ADDENDUM 01

This addendum is considered to form part of the contract document issued for this Request for Quotation. Its content precedes previously issued documents in case of conflicting information.

E-201

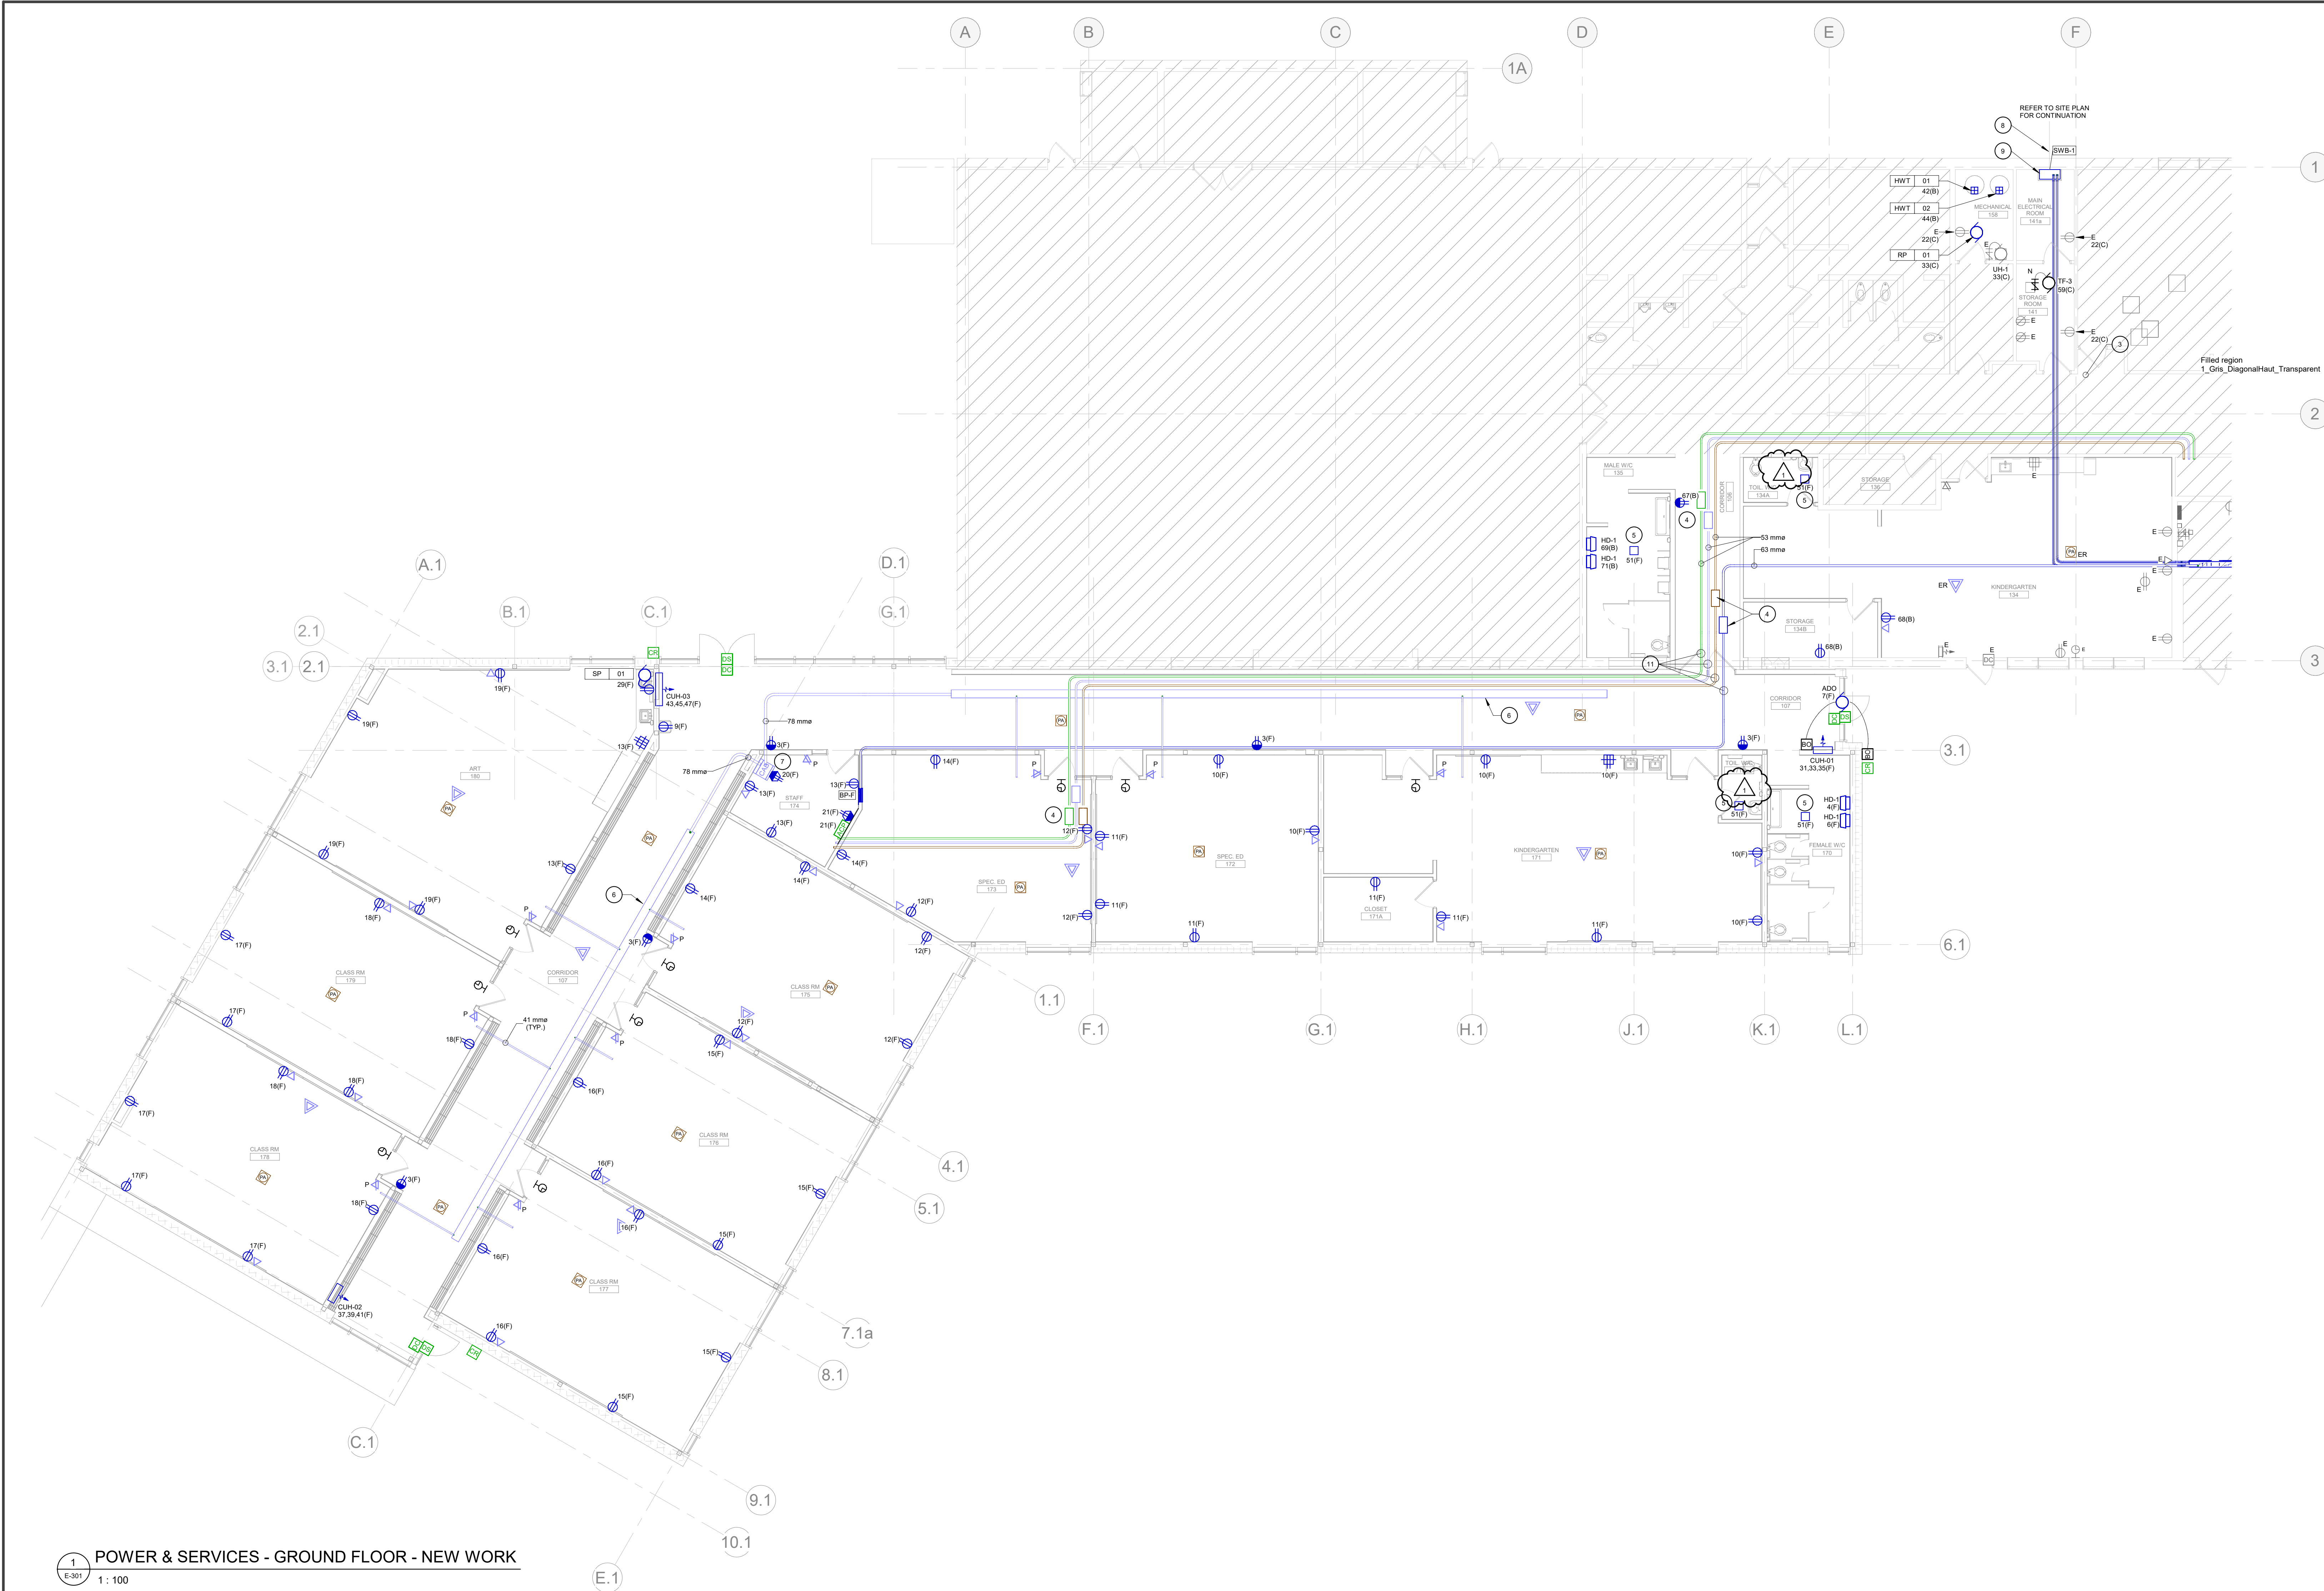
2.4 Drawing E-201

- Revise lighting controls layout as indicated.

1 POWER & SERVICES - GROUND FLOOR - NEW WORK
E-301 1: 100

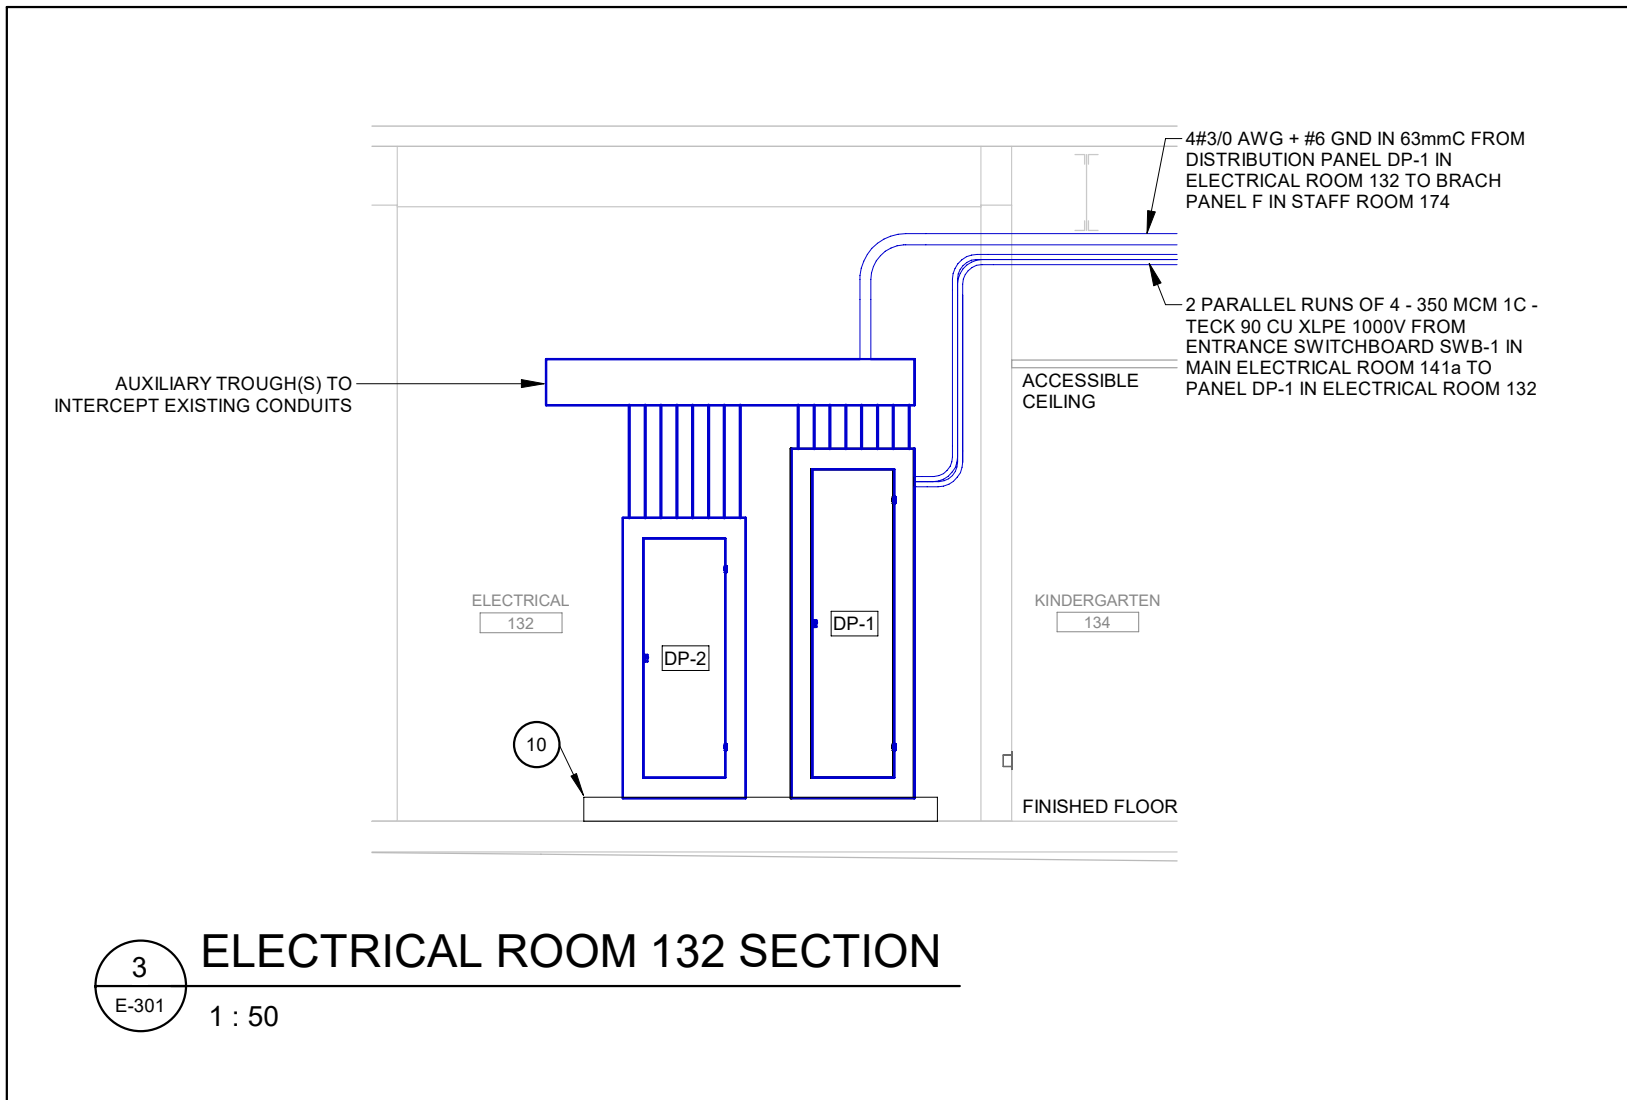
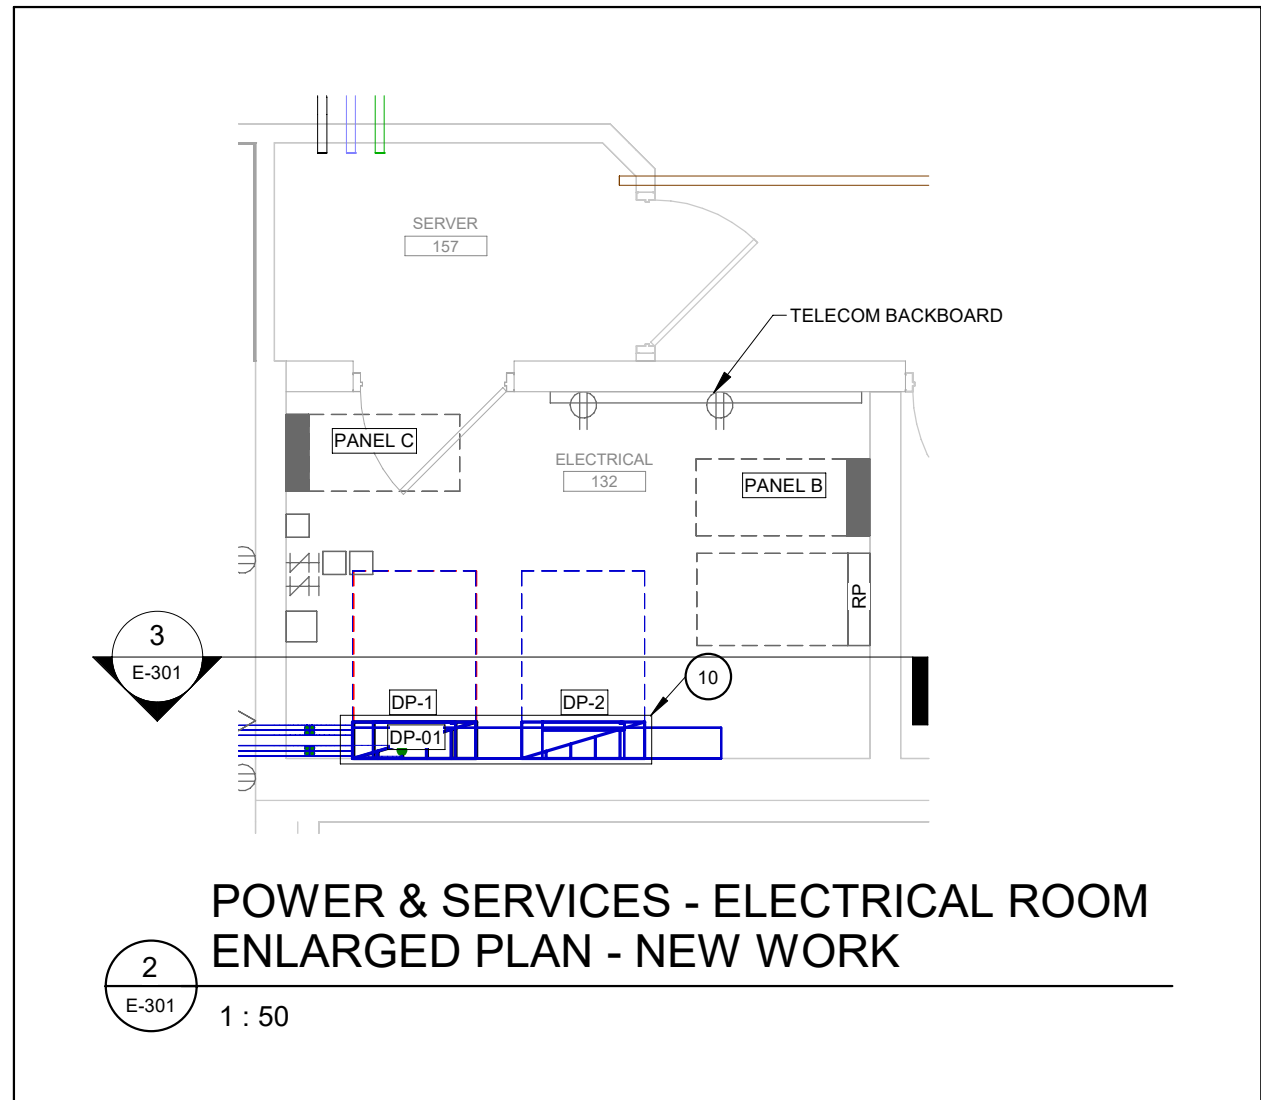
2.5 Drawing E-301

- Remove hand dryers in washrooms 134A and 171B.
